LTR-NRC-22-7

Subject: Fuel Criterion Evaluation Process (FCEP) Notification of the 17x17 OFA PRIME Fuel Product Implementation (Proprietary/Non-Proprietary)

**Fuel Criterion Evaluation Process (FCEP) Notification of the 17x17 OFA
PRIME Fuel Product Implementation**

Figure 1: 17x17 OFA Mid Grid Assembly (Vertical Spring Design)

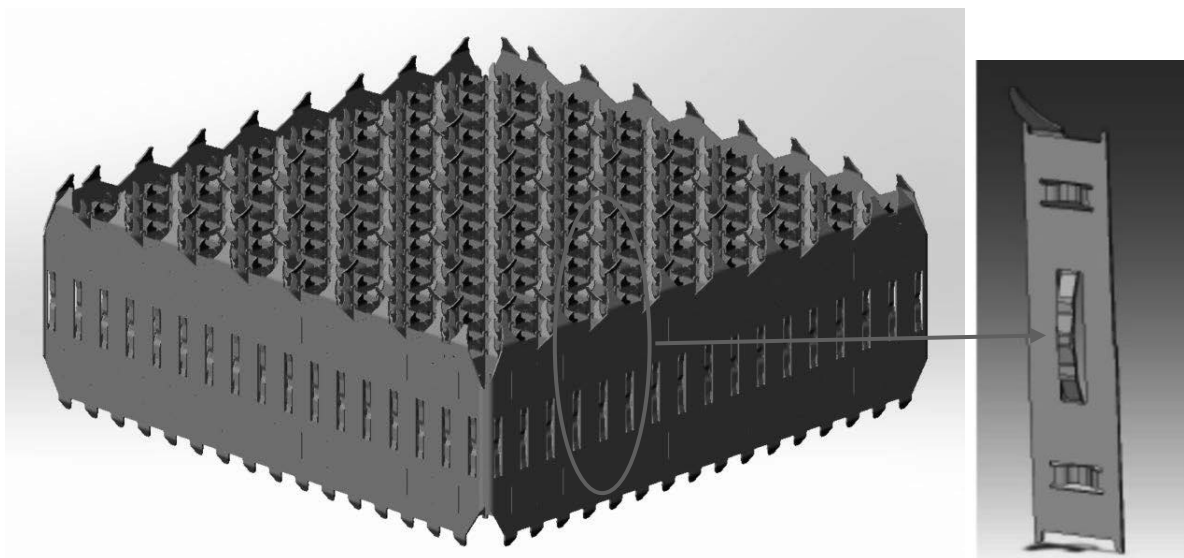
The new grids are essentially identical to the existing **ZIRLO** grids, except that the grid material is **LTZ**. This material change applies to grids with both “balanced” and “unbalanced” vane patterns. The **LTZ** material tends to reduce the corrosion rate, which can provide an incremental benefit for grid growth. For other grid properties, the **LTZ** grid functions in the same manner as traditional **ZIRLO** grids with respect

] ^{a,c} This conclusion applies to both the **LTZ** mid grids and to the **LTZ** IFM grids. All applicable design and safety criteria remain satisfied.

Figure 2: Standardized Debris Filter Bottom Nozzle (3D View)

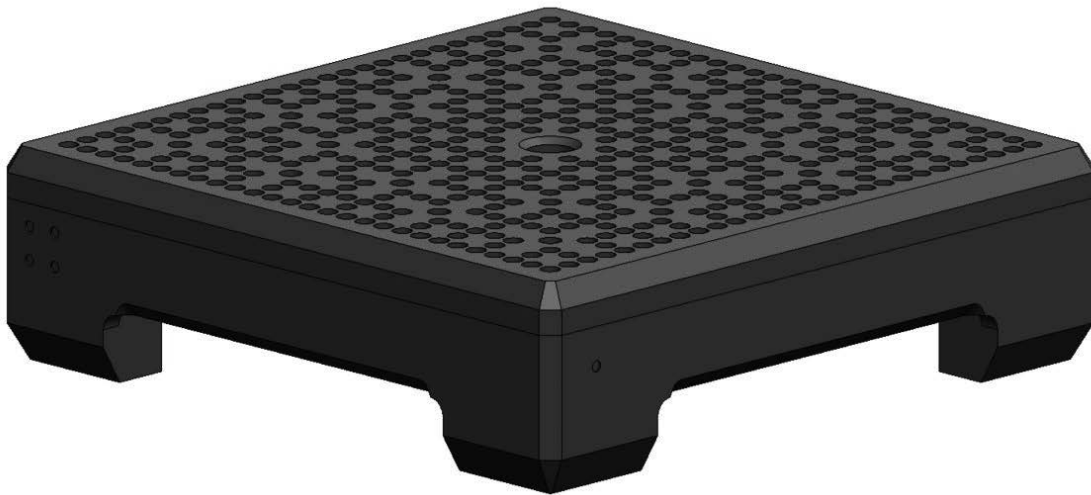
The 17 OFA **PRIME** fuel uses the **PRIME** Bottom Nozzle with low pressure drop flow holes and ADFBN side skirts. The 17x17 ADFBN design is currently being used successfully in operating plants. The **PRIME** Bottom Nozzle has a Next Generation Fuel (NGF) style [

] ^{a,c} as compared to the current SDFBN design shown above. In addition, a second key feature of the **PRIME** Bottom Nozzle design is that the side skirts are lowered for improved debris mitigation as they were for the ADFBN design (Reference 2). Each of these two features are discussed herein and have been previously incorporated into existing bottom nozzle designs, such as for the NGF bottom nozzle design which has [^{a,c} and the 17x17 ADFBN design which lowered the side skirts to improve debris mitigation.

As shown in Figure 2, the SDFBN skirt has an opening that is []^{a.c} This opening could provide a path for debris to migrate into the open channel/gap between fuel assemblies and into the fuel bundle region which could potentially cause debris-induced fretting leakers on the peripheral fuel rods of the fuel assembly.

As a result of this limitation in the design of the 17x17 SDFBN bottom nozzle, the **PRIME** Bottom Nozzle design lowers the side skirts so that they are only []^{a.c} For the **PRIME** design, as shown in Figure 4 and Figure 5, []
